## Service Bulletin No. 054

### **Alternator P/N ES-13070-1 Fan Replacement**

Figure 1 - Fan & Pulley Installation  
(Exploded View)

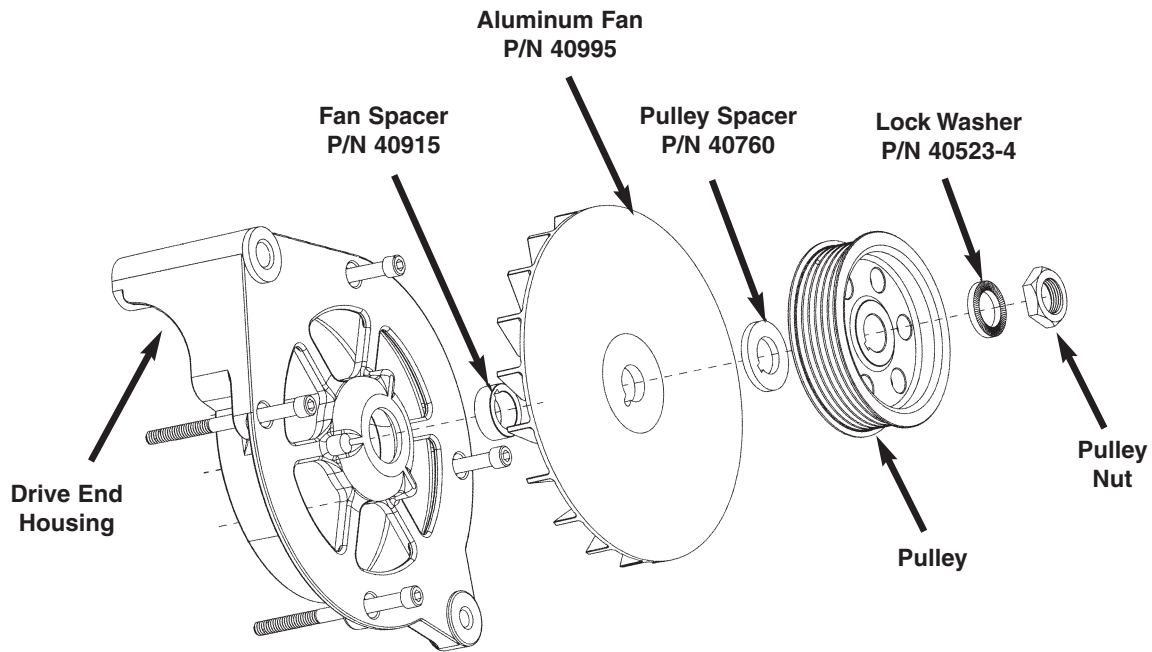
- (1) The corrective action for this service bulletin requires that the steel fan P/N 40397, two spacers, and lock washer be removed and replaced with a new aluminum fan P/N 40995, new pulley spacer P/N 40760, new fan spacer P/N 40915, and new lock washer P/N 40523-4. Replacement may be performed with the alternator installed on the aircraft if adequate access is available.
- (2) To remove the original steel fan (P/N 40397), use the following instructions:

- (ii) Inspect the pulley and pulley nut for condition. If damaged replace.
    - (b) Place the new fan spacer P/N 40915, new aluminum fan P/N 40995, new pulley spacer P/N 40760, and the existing pulley, on the rotor shaft as shown in Figure 1.

- (c) Place a new lock washer P/N 40523-4 on the rotor shaft and apply Loctite® 271 on the rotor shaft threads. Place existing nut on the shaft and tighten.

- (d) Using a strap wrench to hold the pulley and a calibrated torque wrench with a 15/16 inch socket, torque the nut to 67 to 77 ft-lbs to secure fan and pulley assembly.

- (e) Using a dial indicator, zero the indicator on the face of pulley. Rotate pulley to check runout. Runout must not exceed 0.008 inch.
    - (f) Install the belt on the pulley and tension using the appropriate aircraft/engine and/or STC service instructions or manual.

Figure 2 - Typical ES-13070-1 Alternator

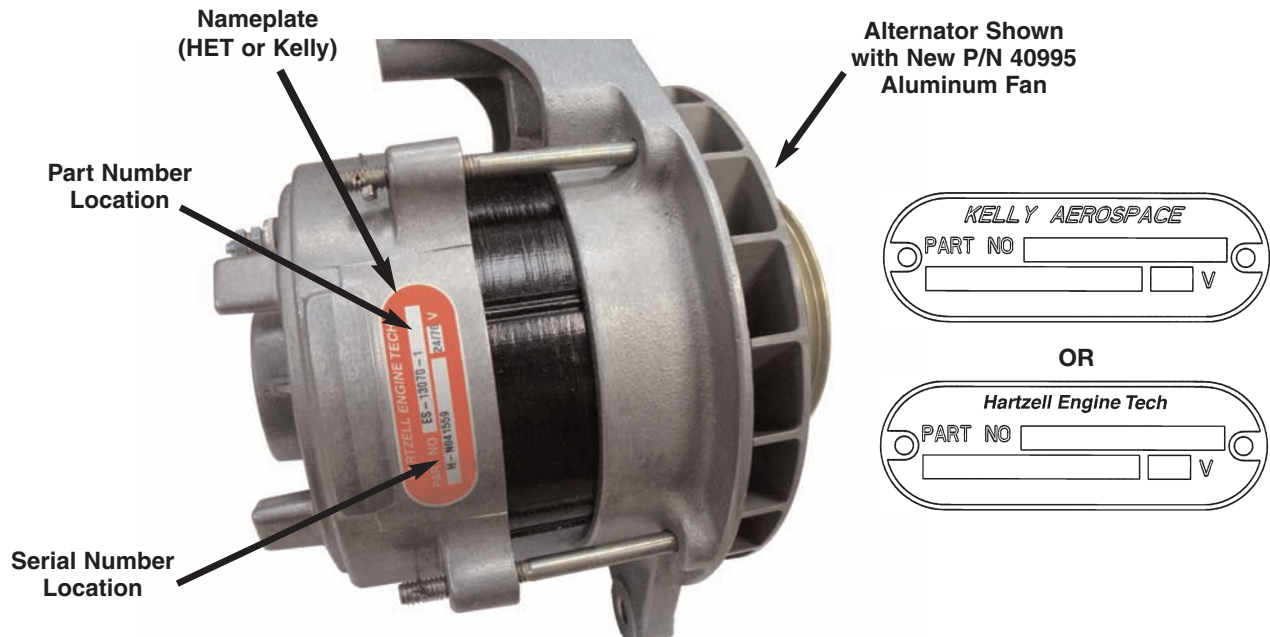
- (1) Locate the alternator nameplate per Figure 2 and observe the serial number. The alternator IS AFFECTED if the alternator has P/N 40397 fan installed (refer to Figure 3) and has S/N J032184 through S/N H-L090932 inclusive.
  - (a) If an alternator within the S/N group above has a fan installation that does not conform to the P/N 40397 fan shown in Fig. 3, the alternator is NOT AFFECTED. Proceed to section 3.D.
